Planning Commission Meeting Agenda

- B. [**PUBLIC HEARING: 3000-3500 Marina Boulevard; Design Permit Modification DP-1-21 \(modification to DP-1-18\); SP-CRO Sierra Point Commercial District; Design Permit revision to modify the exterior materials on all building elevations of the three-building biotech campus previously approved under DP-1-18 \(2018\); David Diamond, applicant; Bp3 Sf5 3000 3500 Marina LLC, owner.**](#)

Planning Commission Agenda Report

SUBJECT: **3000-3500 Marina Boulevard; Design Permit Modification DP-1-21 (modification to DP-1-18); SP-CRO Sierra Point Commercial District;** Design Permit revision to modify the exterior materials on all building elevations of the three-building biotech campus previously approved under DP-1-18 (2018); David Diamond, applicant; Bp3 Sf5 3000 3500 Marina LLC, owner.

Building 1 Ends

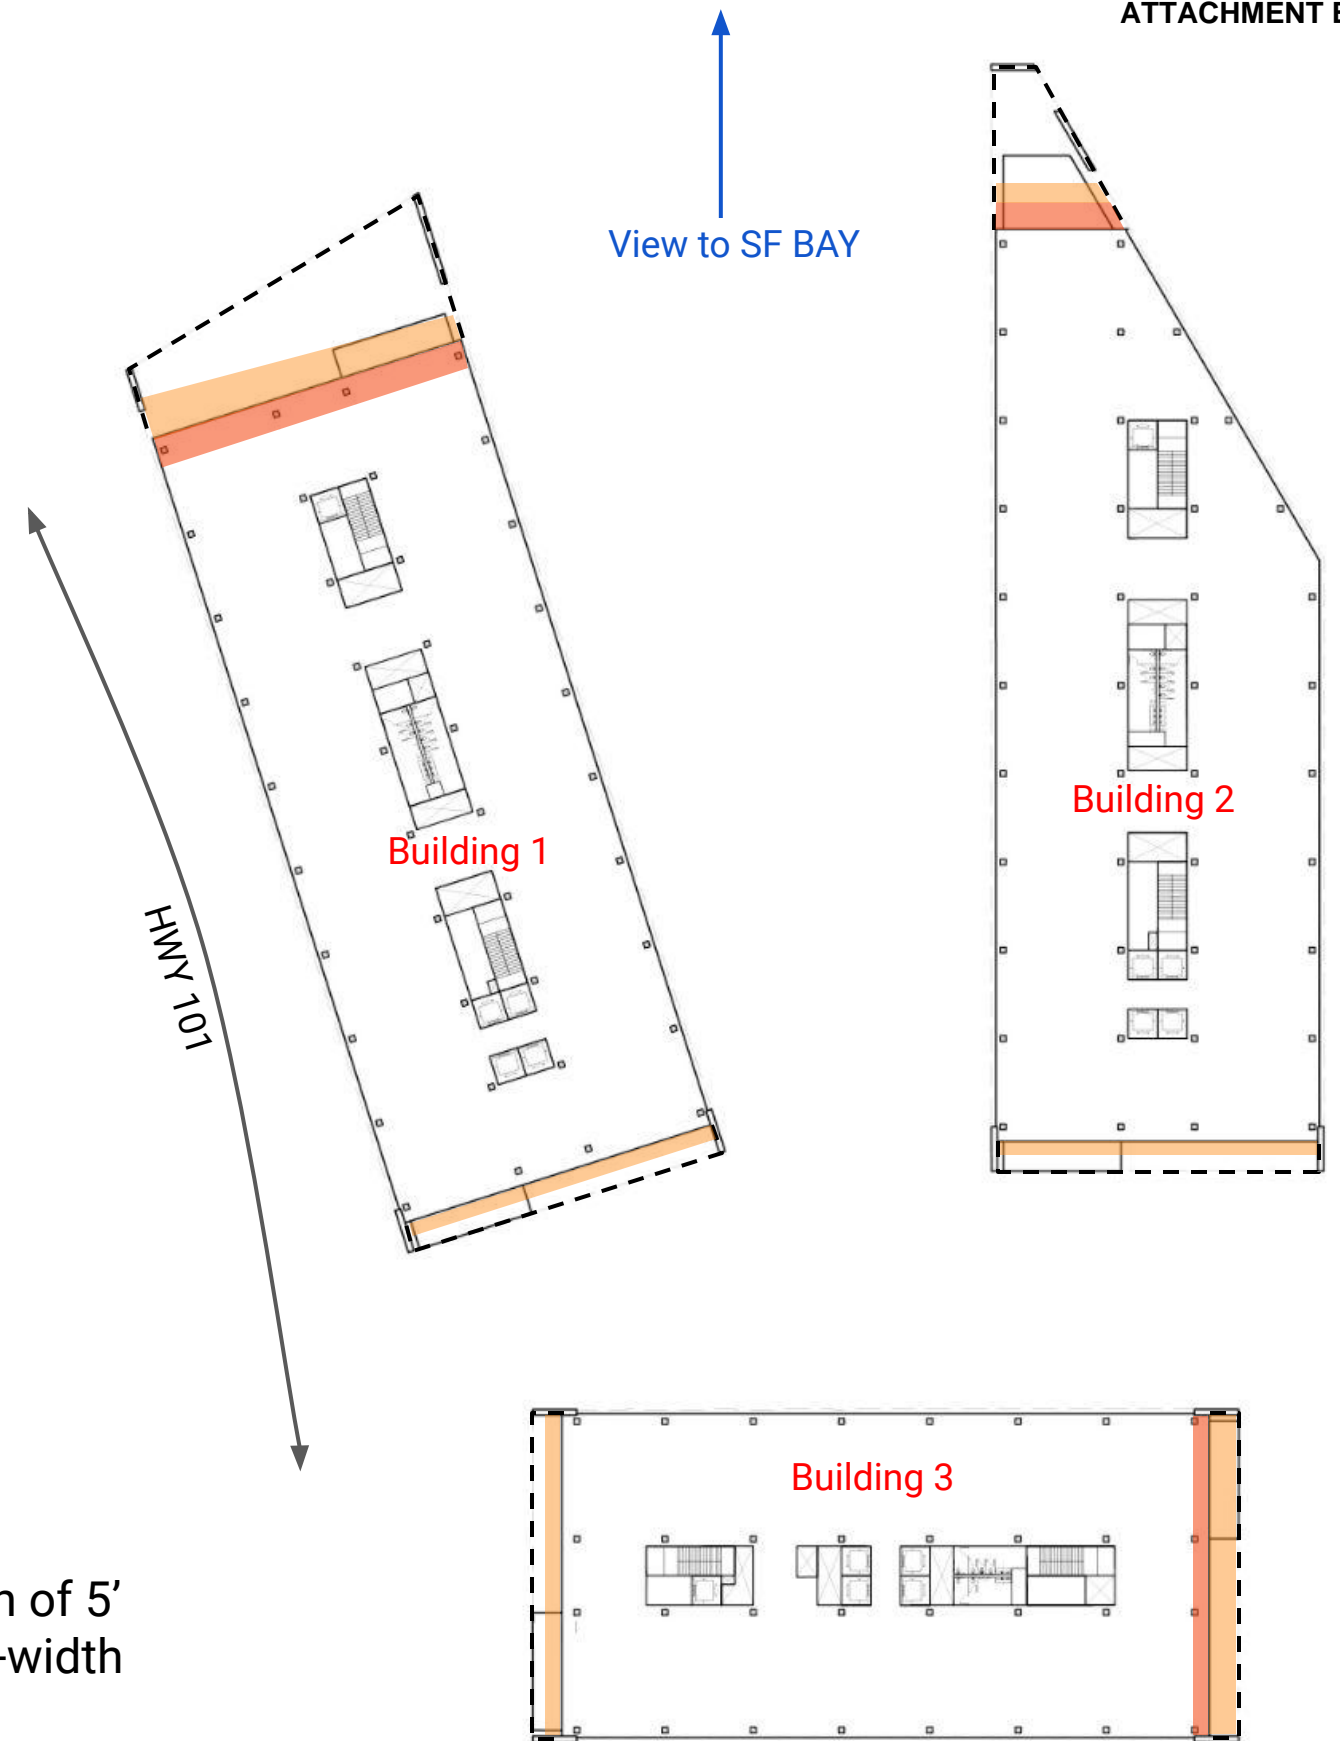
- North frame overhanging roof projection reduced to a dimension varying 5' to 10'
- South frame overhanging roof projection reduced to a dimension of 5'
- North end partial-width projecting balconies at L4 & L6 replaced with full-width inset and covered balconies at L3 & L6
- South end partial-width projecting balconies at L4 & L6 removed

Building 3 Ends

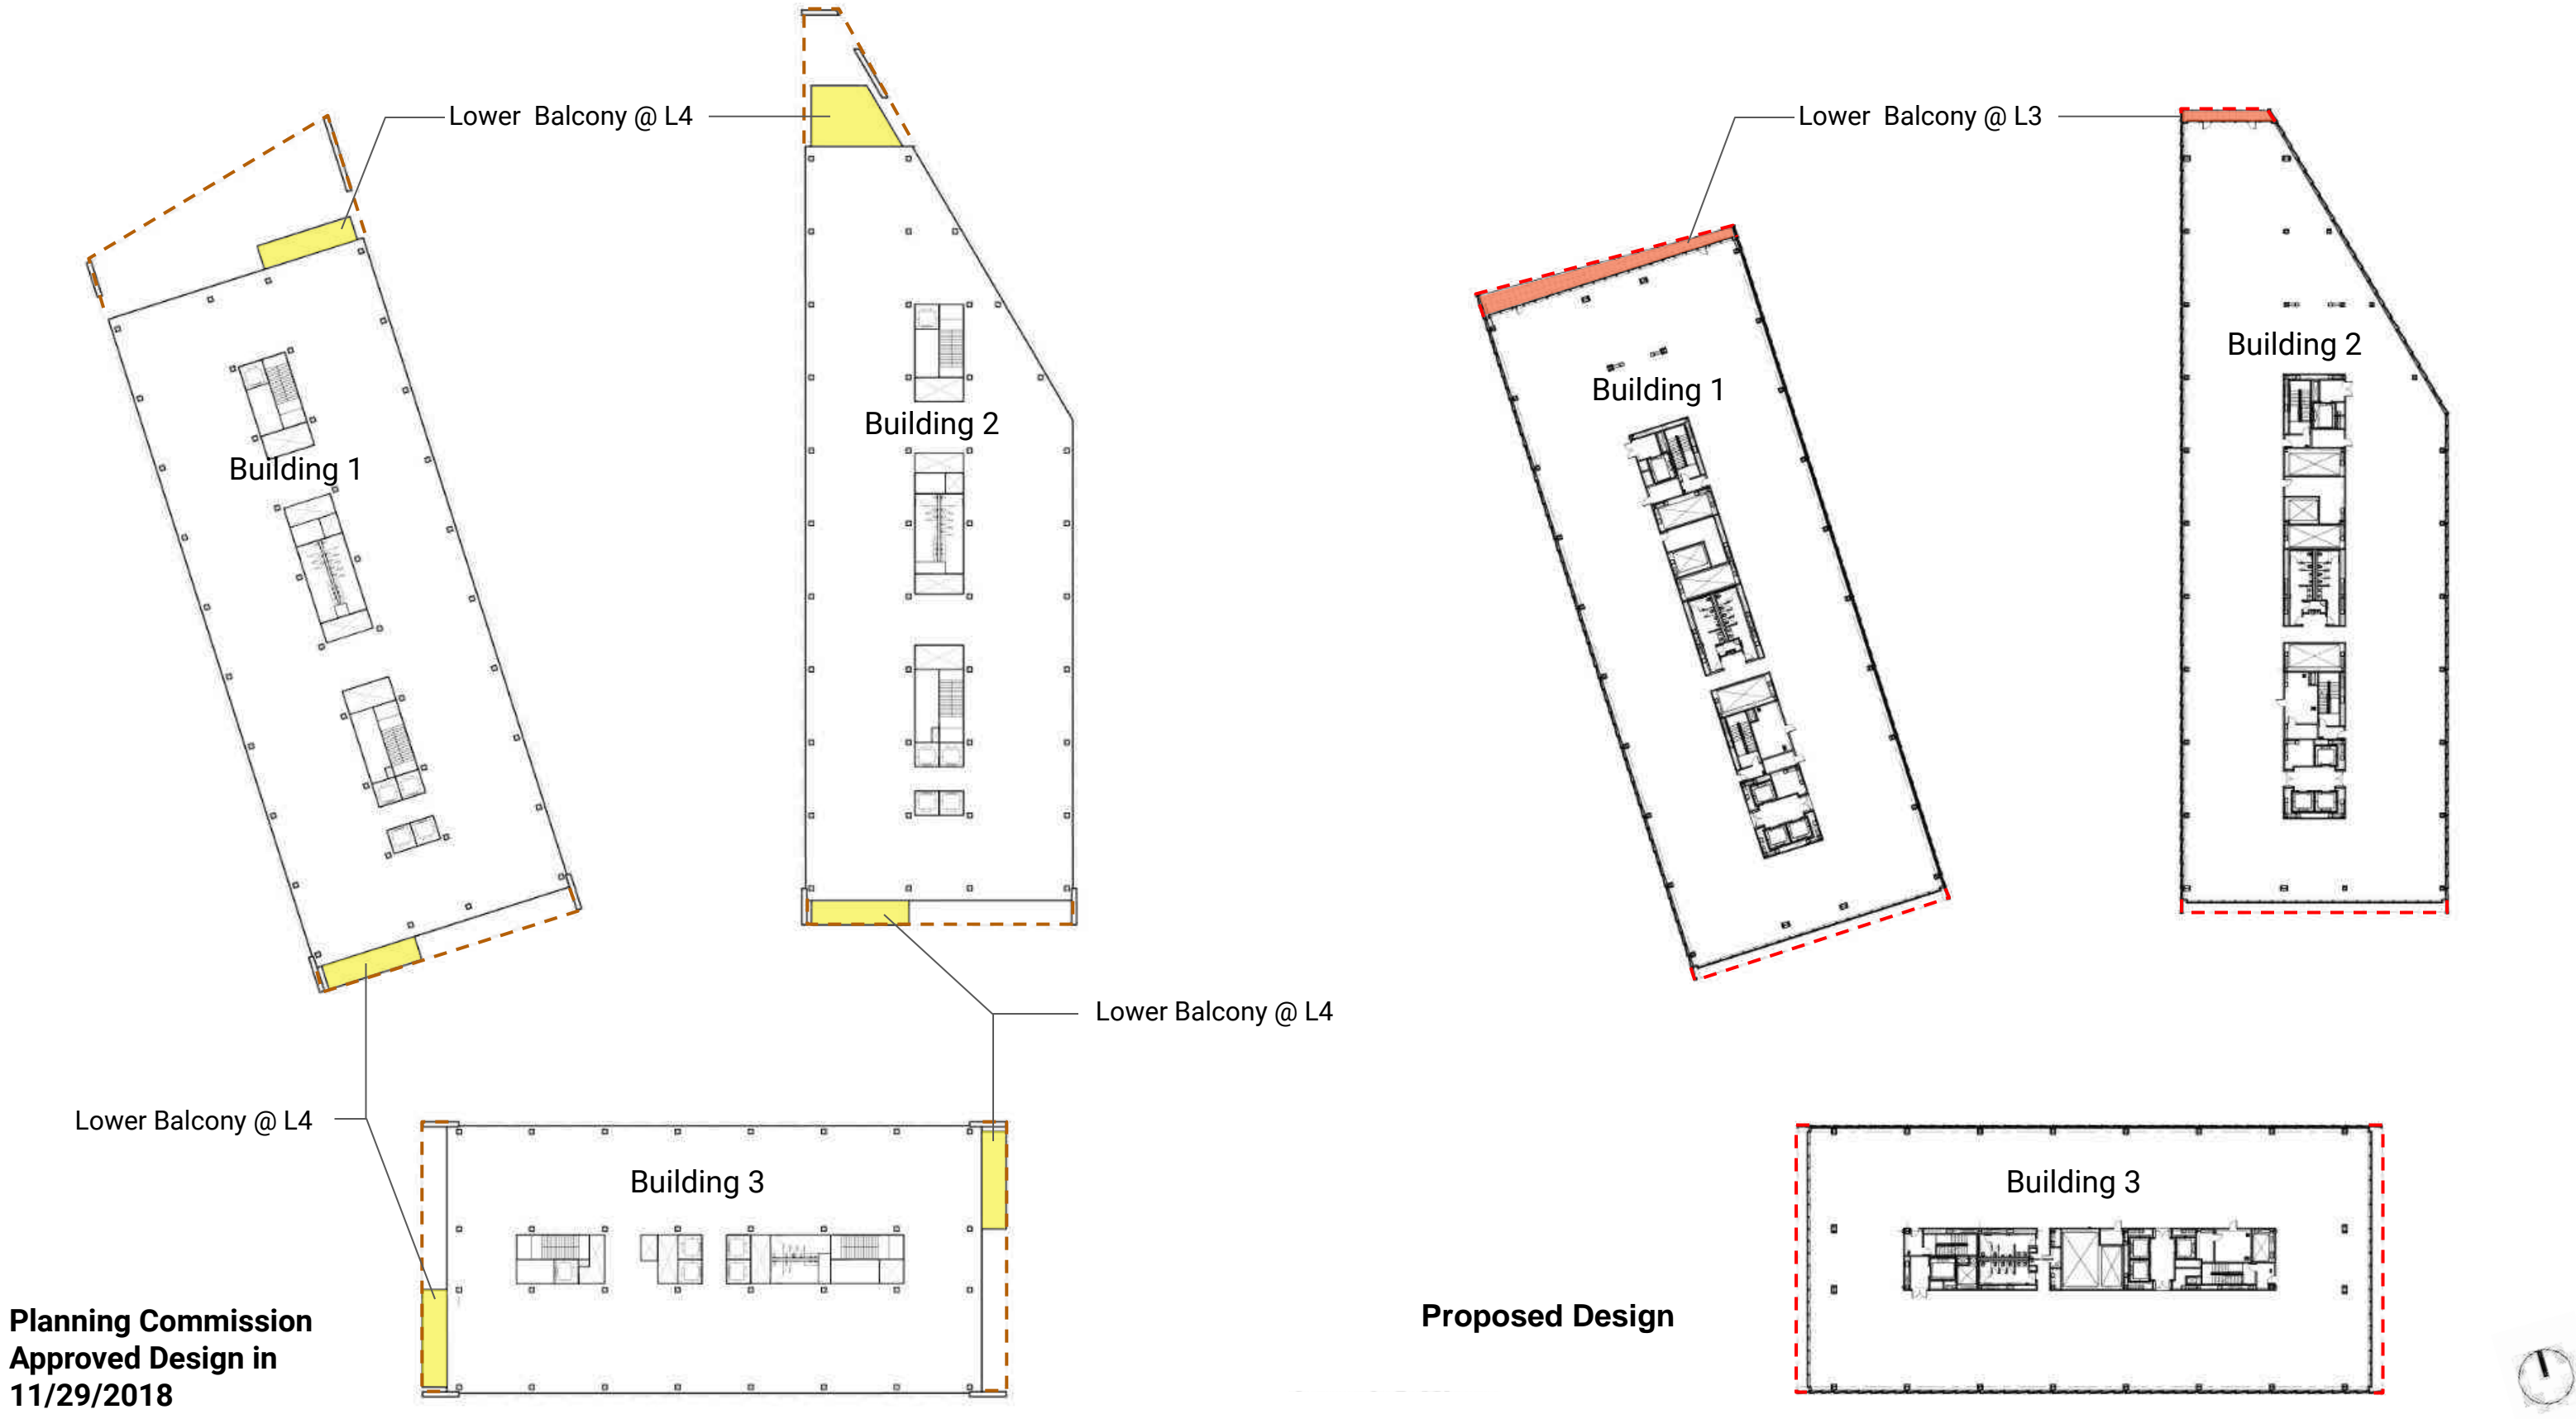
- East & West frame overhanging roof projections reduced to a dimension of 5'
- East end partial-width projecting balconies at L4 & L6 replaced with full-width inset and covered balcony at L7
- West end partial-width projecting balconies at L4 & L6 removed

Exterior Wall - Outward Facing Long Building Elevations

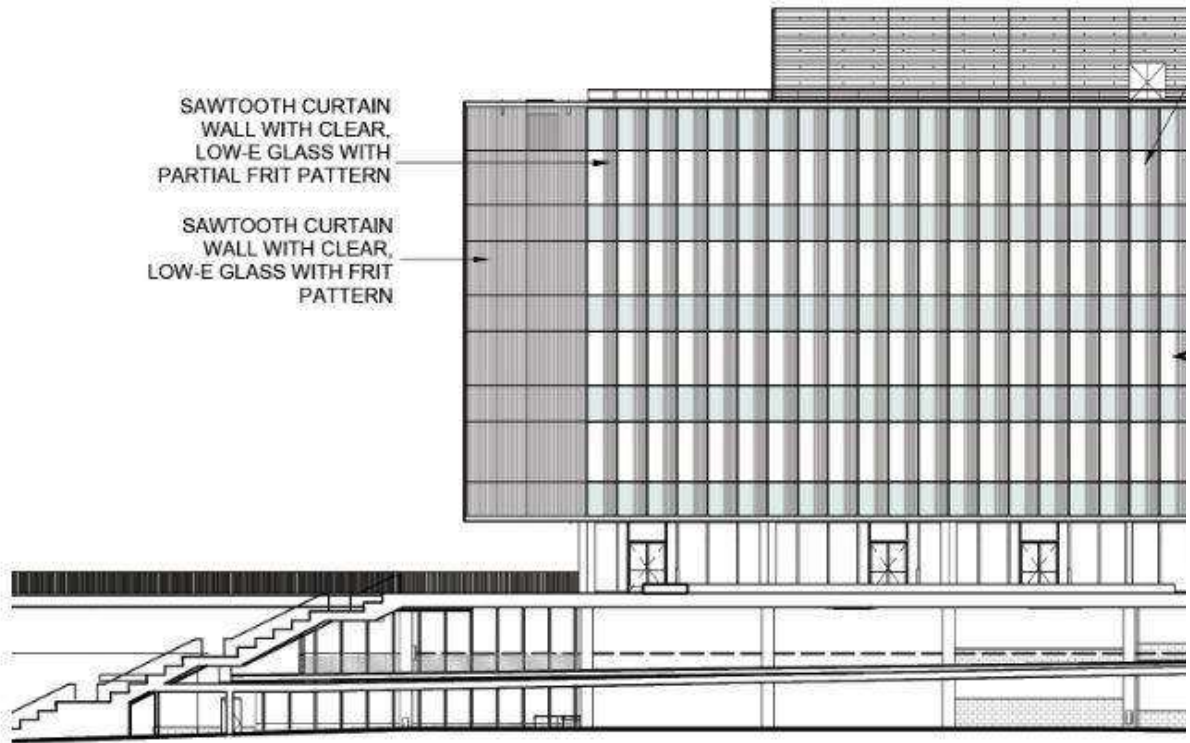
Flat glass curtain wall with projecting horizontal aluminum fins replaced with “sawtooth” curtain wall units with integral vertical fins on one side of each unit.

Proposed Exterior Wall Design- Solar Orientation

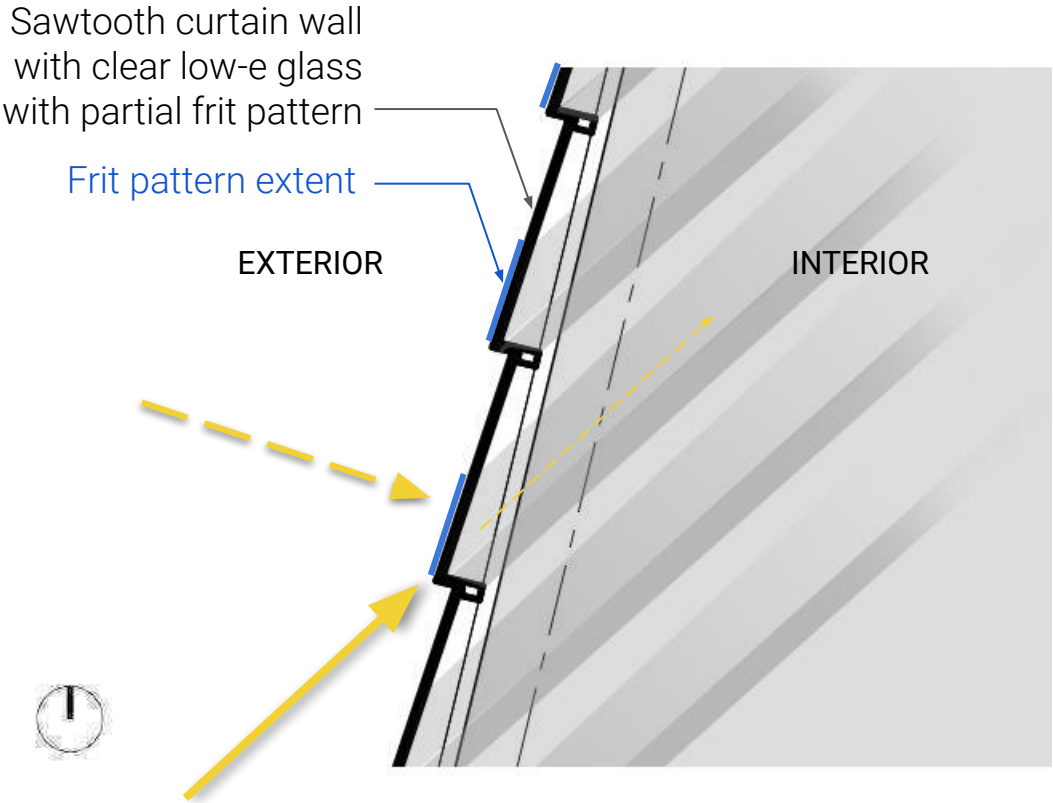
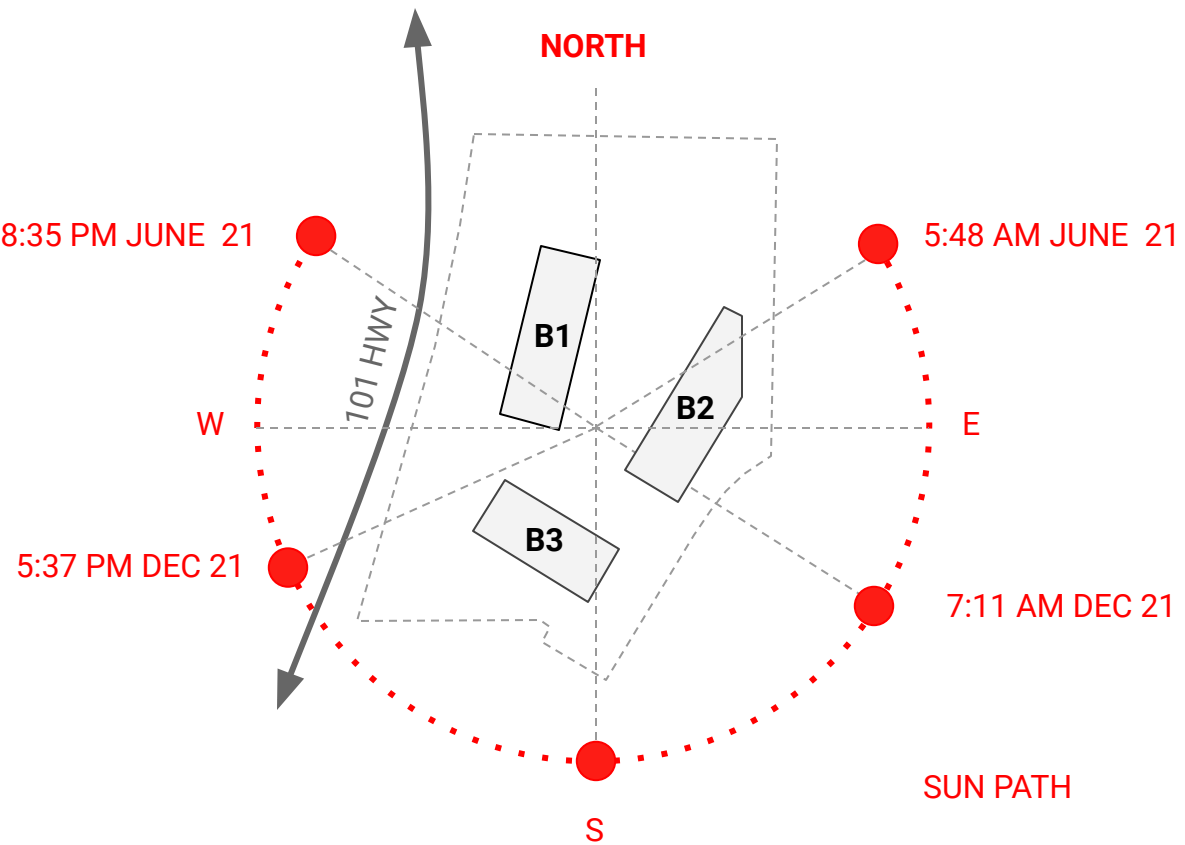
- The vertical projection on the sawtooth geometry helps shading from the south and southwest sun.
- The frit pattern helps shading and overall glare reduction from the low western and eastern sun.
